# SERVICE No ~~334~~ BULLETIN

Piper Aircraft Corporation

Subject: Alternate Air Hose Replacement

Models Affected: PA-23-250 (Six Place) Turbocharged Aztec

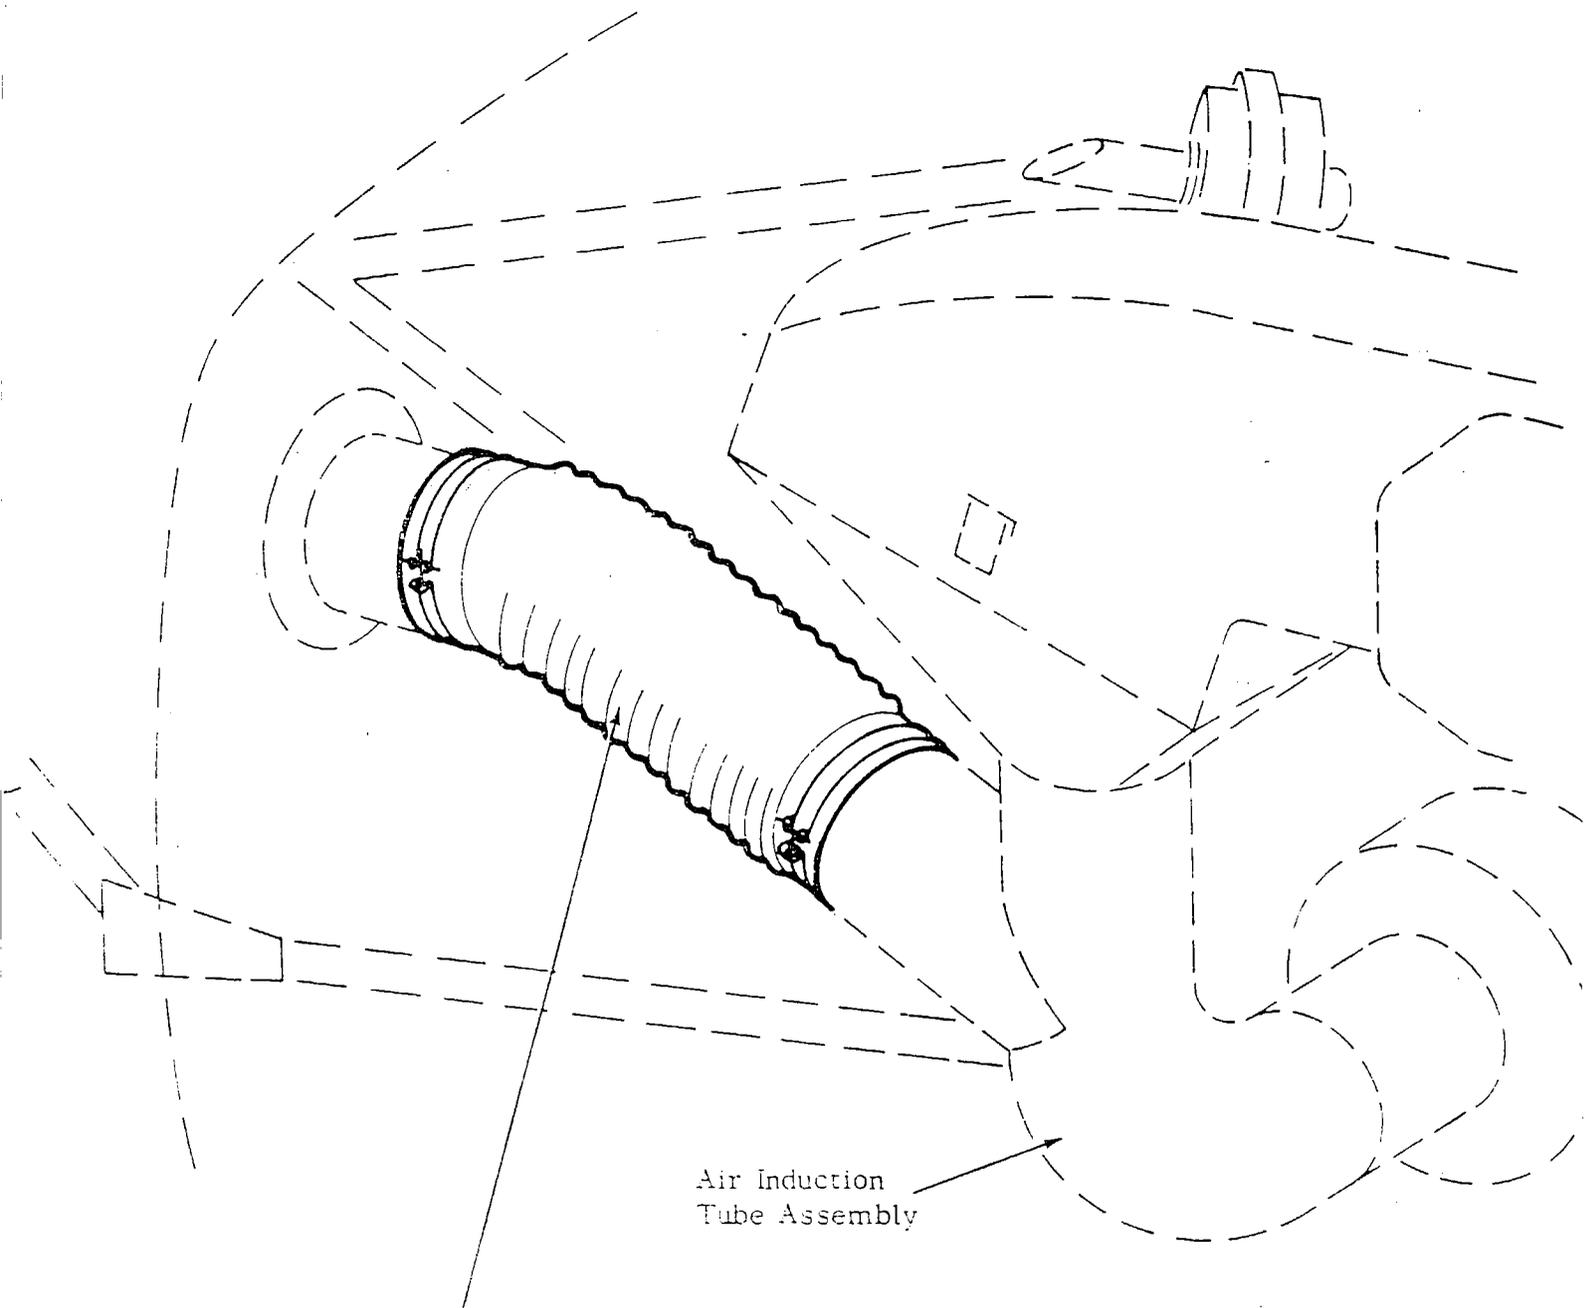
Purpose: To replace the existing Alternate Air Hoses on the above referenced aircraft with new improved Alternate Air Hoses.

Instructions: Replace existing Alternate Air Hoses with new Alternate Air Hose, Piper part number 48076-02, per the Sketch/Instructions contained on the reverse side of this publication.

Remove the existing Alternate Air Hose and install new hose, Part No. 48076-02, using existing clamps.
